CITY OF FRANKLIN
PLAN COMMISSION MEETING*
FRANKLIN CITY HALL COUNCIL CHAMBERS
9229 W. LOOMIS ROAD, FRANKLIN, WISCONSIN
AGENDA
THURSDAY, JUNE 22, 2023, 7:00 P.M.

REPORT TO THE PLAN COMMISSION

New Planned Development District and Comprehensive Master Plan Amendment

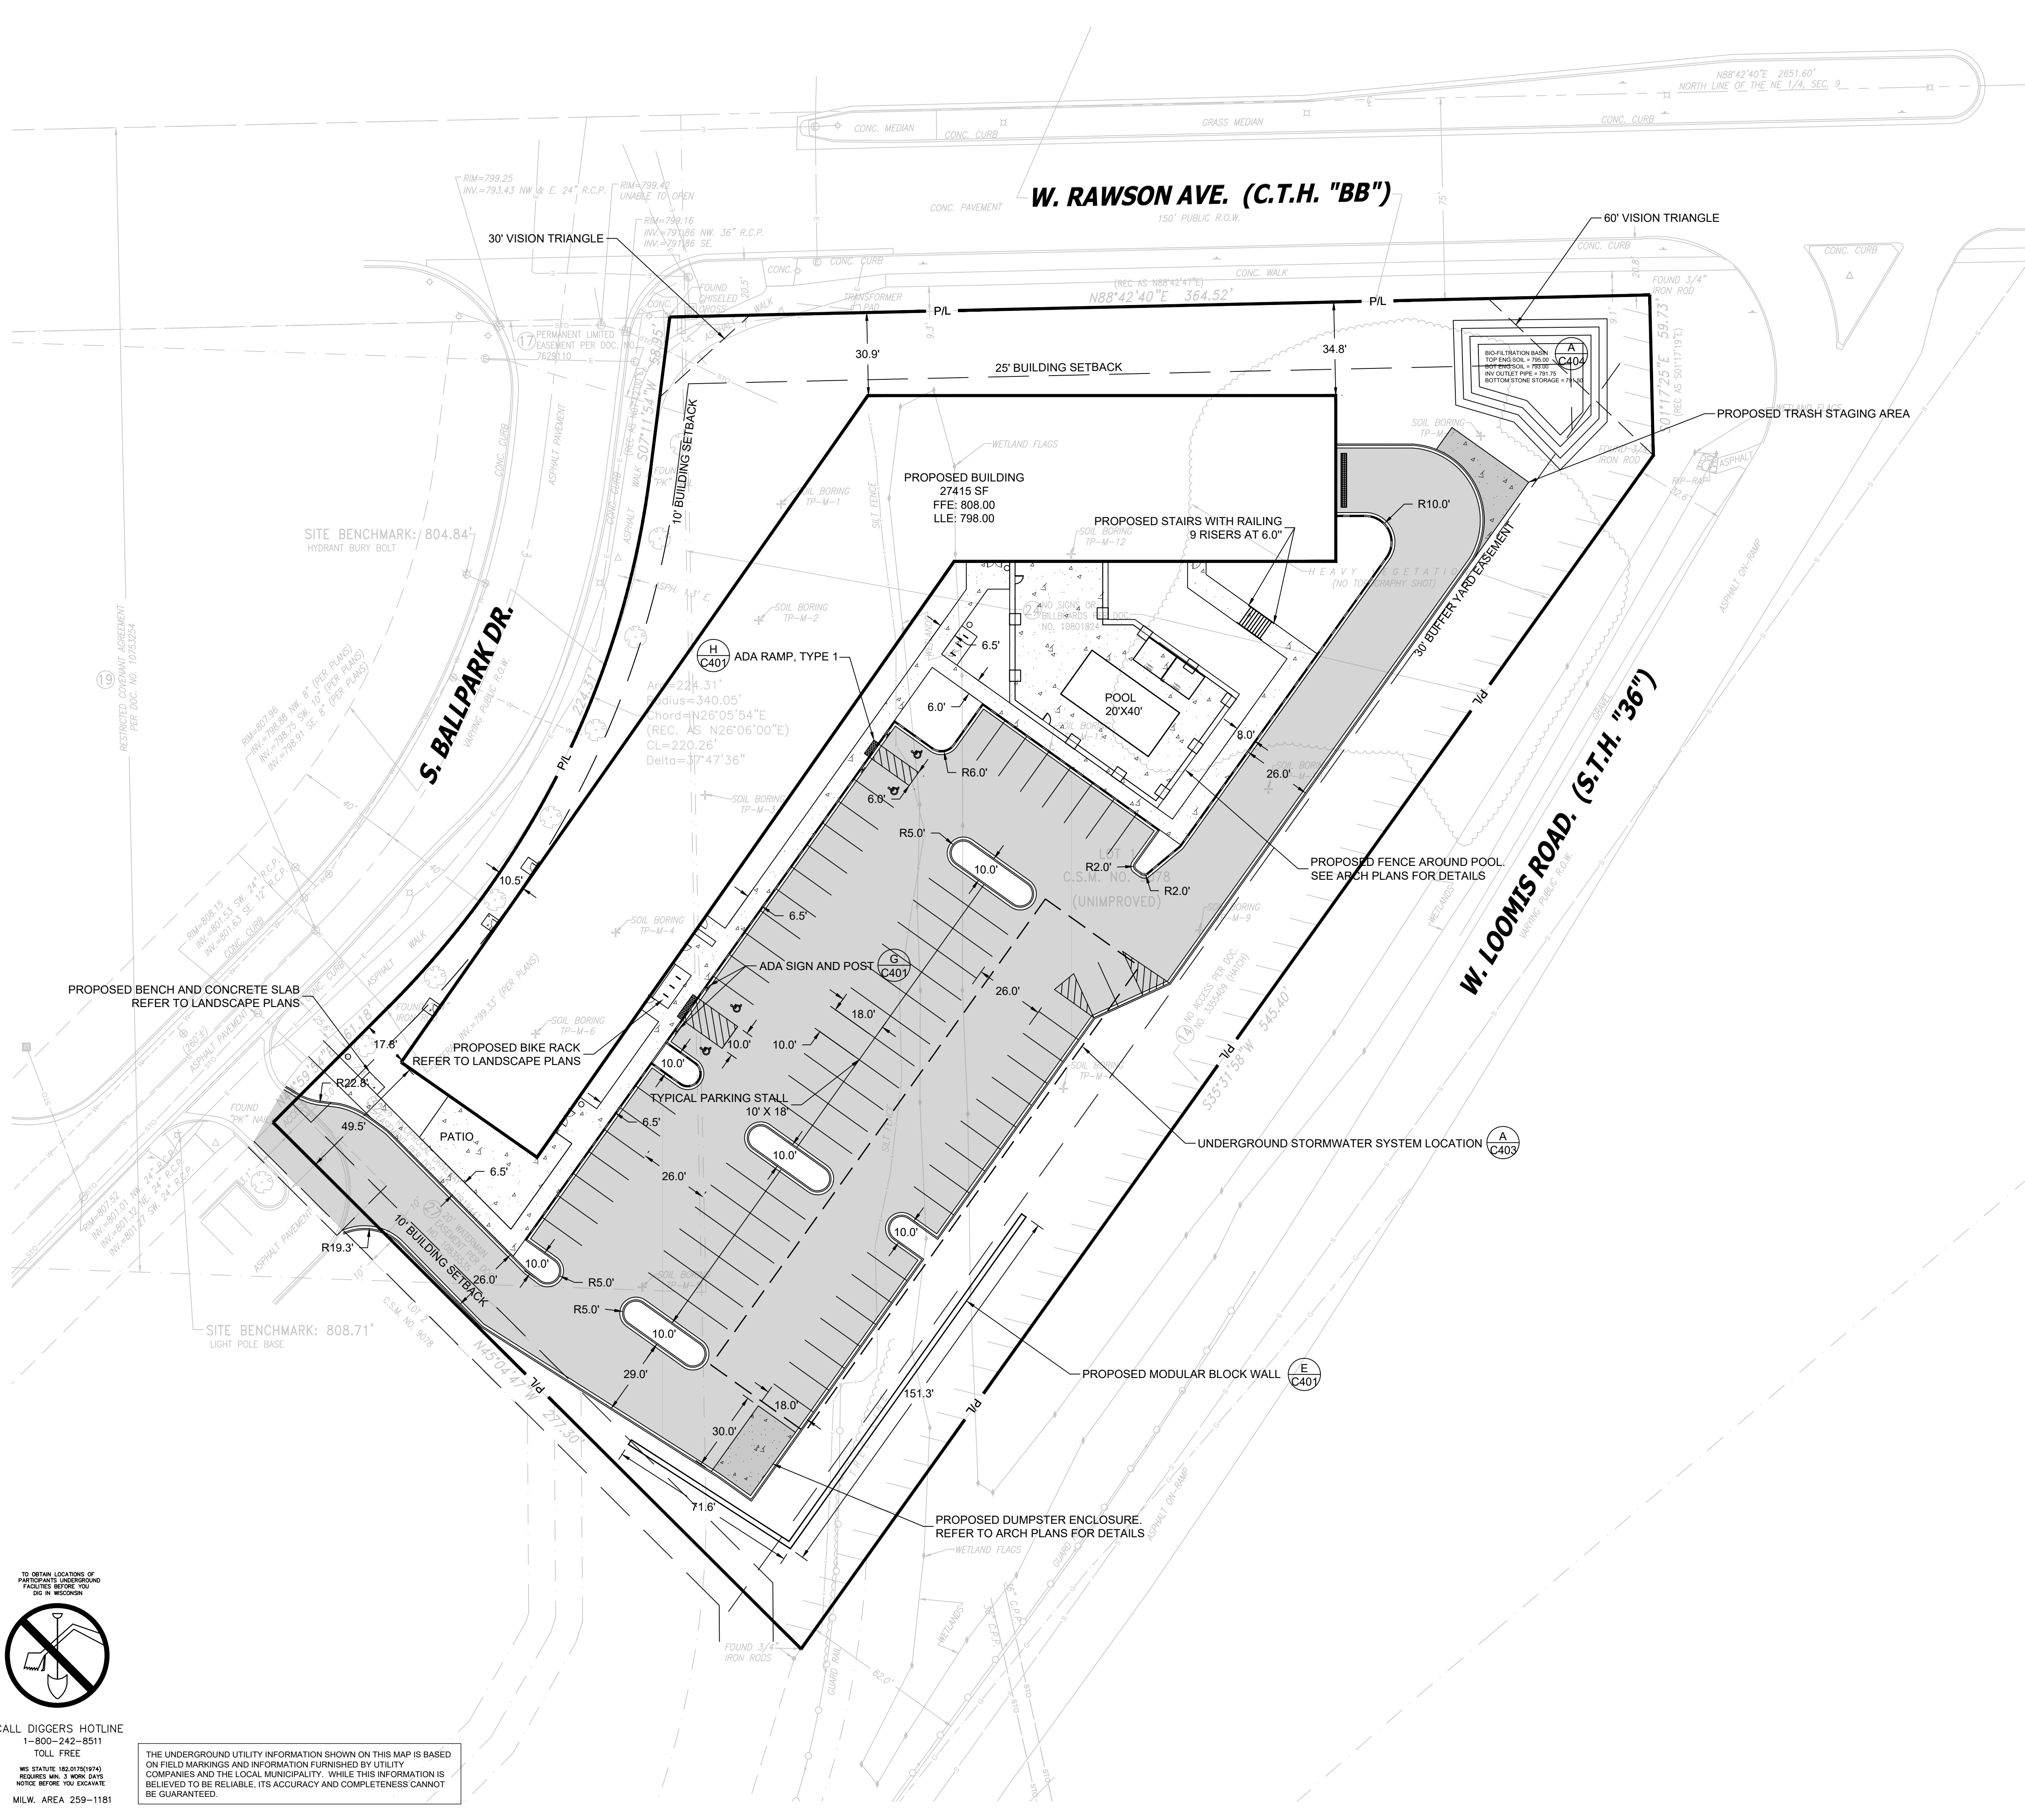
15. The Site Information table on Sheet C100 states an Existing Impervious Area of 3.122 AC/100% of the site. As the site is vacant, I believe this is meant to be Existing Pervious Area. Please review and revise accordingly.

19. Please double check the parking space count within the Site Information table on Sheet C100. It appears there are 99 surface parking spaces, including 4 ADA accessible spaces, opposed to 96 and 3. Please revise accordingly.
